NOAA WIND PROFILER MODIFICATION NOTE 6

SUBJECT : Installation, RF Gain Adjustment, and Sensitivity Time Control

PURPOSE : Replacement of the Type 1 receiver

EQUIPMENT AFFECTED: All 404 MHZ wind profilers.

Figure 2 Profiler Status Data Block Screen on the PMT

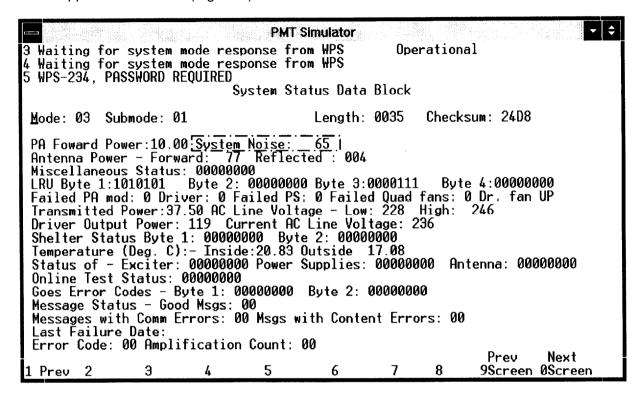
- 4. Once the PMT has logged onto the profiler system, allow the radar to go through one or two complete beam cycles as indicated by the BSU front panel LEDs. Beam cycles start and end in the east-high mode. As the radar completes one beam cycle, the front panel LED marked EAST will light.
- 5. Select *Display Current Output* from the PMT Main Menu. Select *Landline* from the menu. Select *Status Data* from the menu. The *System Status Data Block* screen will appear on the PMT (Figure 2).

6. Locate the *System Noise* field on the PMT screen. This number should be 63 ±1 with J1 (RF IN) terminated. To assure repeatability of the system noise value, allow the radar to cycle through the beams several times. Press *F1* on the PMT each time the east beam is reached. Select *Status Data* again and check the System Noise.

If the system noise is 63 \pm 1, no adjustment is required. Proceed to the STC alignment procedure in Section E. If the system noise value is too high or too low, proceed to the receiver gain adjustment in Section D.

Figure 3 Receiver Gain Adjustment

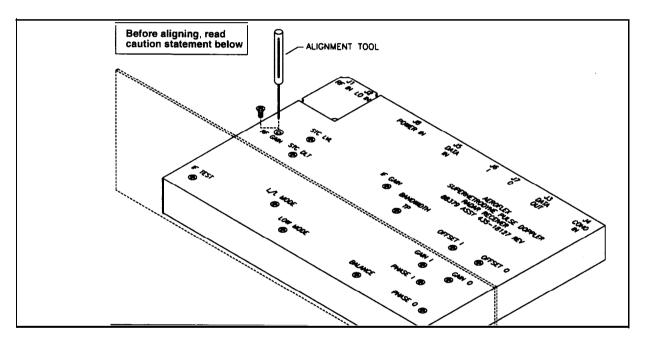
The receiver gain is changed by adjusting a potentiometer (pot) that is accessed by removing a port-screw, labeled *RF GAIN*, from the top panel of the receiver. The pot is a surface mount device and is very small (the screw in the pot is about the size of a pinhead). A special alignment tool is provided with the Type 2 receiver for adjusting these pots and should always be kept at the site.

- 1. Remove the blank panel above the receiver. This will allow easier access to the gain adjustment pot.
- 2. Remove the port-screw from the top of the receiver labeled RF GAIN and carefully insert the alignment tool in the hole as shown in Figure 3. Since the pot is not visible, it is necessary to rely on the "feel" to seat the alignment tool in the potentiometer screw head.

Considerable care must be taken when making adjustments on this pot. Rotations of just a few degrees will cause significant changes to the receiver's gain.

- 3. Make small changes on the *RF GAIN* pot. Wait for the radar to cycle to the east beam and use the PMT to verify the system noise as described in Section 5. Repeat this process until the system noise value of 63 ±1 is obtained. Once this value is reached, verify consistency of the system noise value by checking several more continuous beam cycles.
- 4. Replace the *RF GAIN* port-screw on the receiver top panel.
- 5. Power-down the radar as described in Section A, step 1.
- 6. Remove the 50 Ω load from J1 (RF IN) and reconnect the coaxial cable between J1 on the receiver and the T/R switch.

Figure 4 Accessing the T/R Switch Trigger Pulse Inside the Signal Processor for the STC Alignment Procedure.

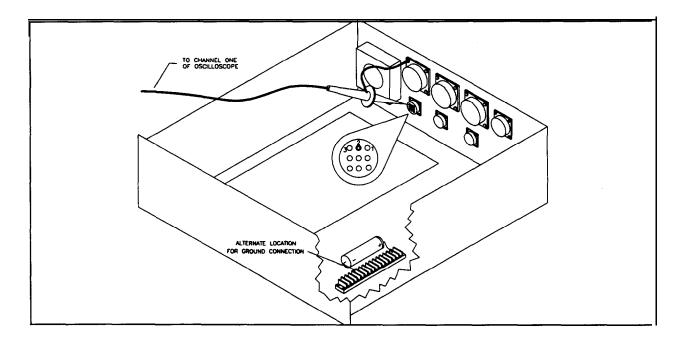
- 1. Power-down the radar as described in section A, step 1.
- 2. Remove the four mounting screws from the front panel of the signal processor and pull the unit to its full out position. Remove the top cover panel from the signal processor.
- 3. Connect a probe to channel one of the oscilloscope. Unscrew the grabber-tip from the probe to expose the pointed tip. Locate J3 pin 2 inside the rear panel of the signal processor. Insert the scope probe into pin 2 of connector J3 as shown in Figure 4.
- 4. Screw an SMA to BNC adaptor onto connector J6 (/n-phase) or J7 (Quadrature) on the rear panel of the receiver. Connect a coax cable (with BNC connectors on both ends of the cable) between channel two of the oscilloscope and J6 (/n-phase) or J7 (Quadrature) output on the rear panel of the receiver
- 5. Oscilloscope Settings:

Time/Division = 5 μ Sec
Channel One:
Triggering on channel one = positive edge
Volts/Division = 2 (0.2 for XI0 probe)
Channel Two:
Volts/Division = 200 mV

Figure 5 Typical STC waveform on an oscilloscope. Top trace is the T/R switch gating signal. Bottom trace is the video signal present at J6 (I) or J7 (Q) output of the receiver.

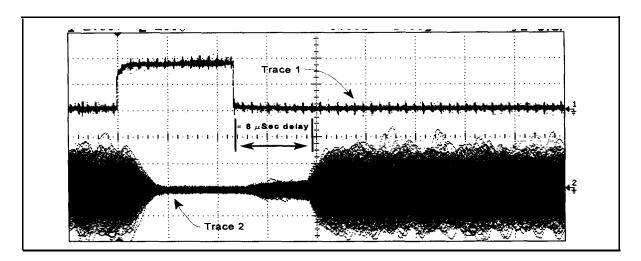
- **6.** Remove the two screws from the STC LVL (level) and STC DLT (delay) ports on top of the receiver. Refer to Figure 3.
- 7. Power-up the radar in the sequence as described in section C, step 2.
- 8. The oscilloscope will display waveforms similar to those shown in Figure 5. This figure shows the entire T/R pulse in reference to the receiver's video signal waveform. The STC circuitry is factory preset for * δ 8 μSec delay (measured from the falling edge of trace 1) and an attenuation level of 15 dB (* 300 mV p-p). These settings must be fine-tuned on a site-by-site basis to achieve the maximum benefit from the STC circuit.

Figure 6 Effects of changing the STC DLT and STC LVL. Top trace is the T/R Switch Gating Pulse. Bottom trace is the Video Signal present at J6 (I) or J7 (Q) output of the Receiver.

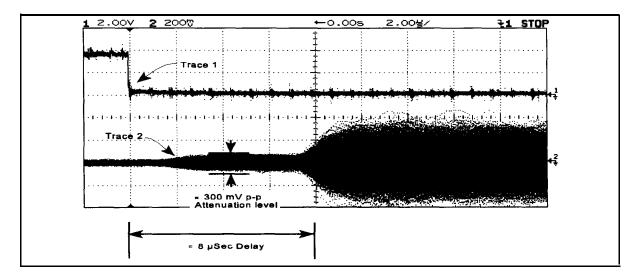
9. Change the oscilloscope settings to 2 μ Sec/division, and trigger on the negative going edge of trace 1. This will provide greater resolution on the oscilloscope screen. Figure 6 shows the negative going edge of the T/R switch gating signal (top trace) and the effect of the STC circuit on the waveform (bottom trace). The STC is triggered on the negative edge of the T/R gating signal. The duration of the clamp is set by adjusting the STC DLT. The amplitude of the clamp is set by STC LVL.

Care must be taken when making adjustments to the STC DLT and STC LVL pots. They are extremely delicate. Do not attempt to adjust these pots without an oscilloscope.
